A-579372

666A XMTR A 579370
USED ON DWG

666A TRANSMITTER WIRING DIAGRAM & SCHEMATIC

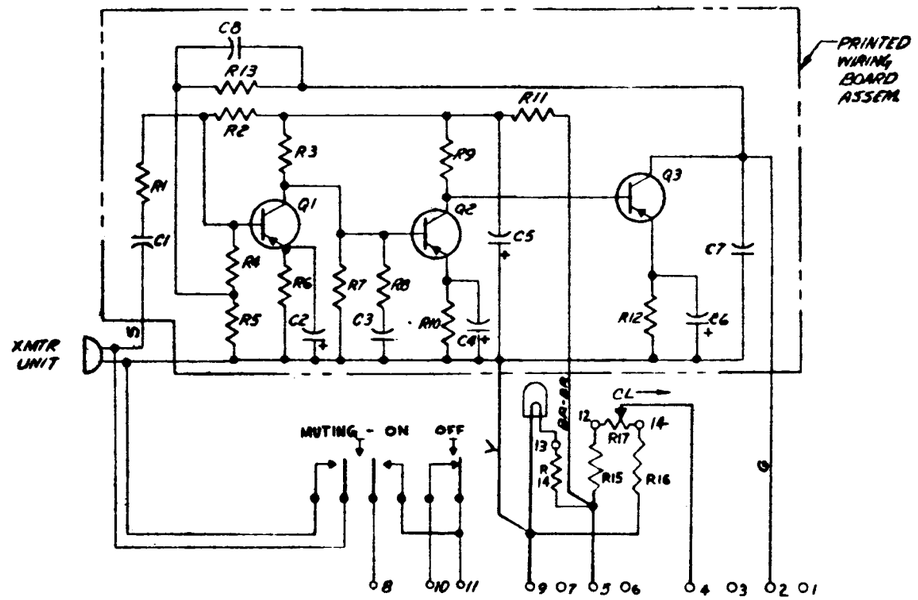
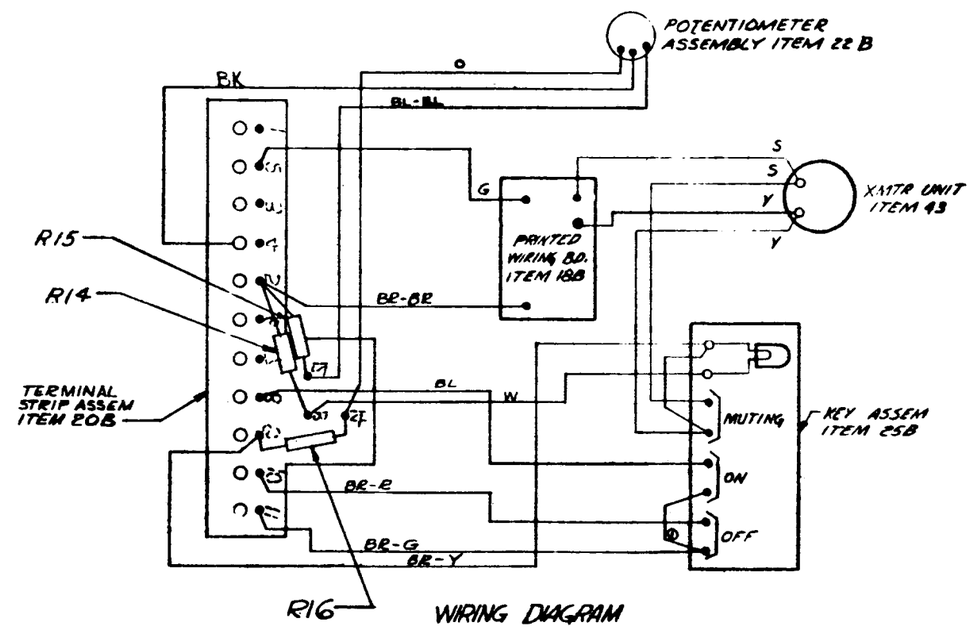
R.D.'S ENGRS	W.V.K.		
DRAWN C.A. SCHULER	C.S.		
ISSUE-L 1-18-61			
DRAWN A.J.B.	W.G.B.		
ENGR INDEX	E.C.		
ENGR BTL	W.S.E.		
ISSUE-I 2-9-60			
ON WIRING DIAGRAM, TERM STRIP WAS WIRED FROM OTHER SIDE AS VIEWED ON DWG. ON KEY ASSEM STRAP WAS BETWEEN "MUTING" & "ON". LAMP WAS TO "ON". ON SCHEMATIC, "ON" CONTACT WAS WIRED TO LAMP. (441DGB-A1-C)			
DRAWN BY K.A.			
ENGR INDEX			
ISSUE-E 8-22-60
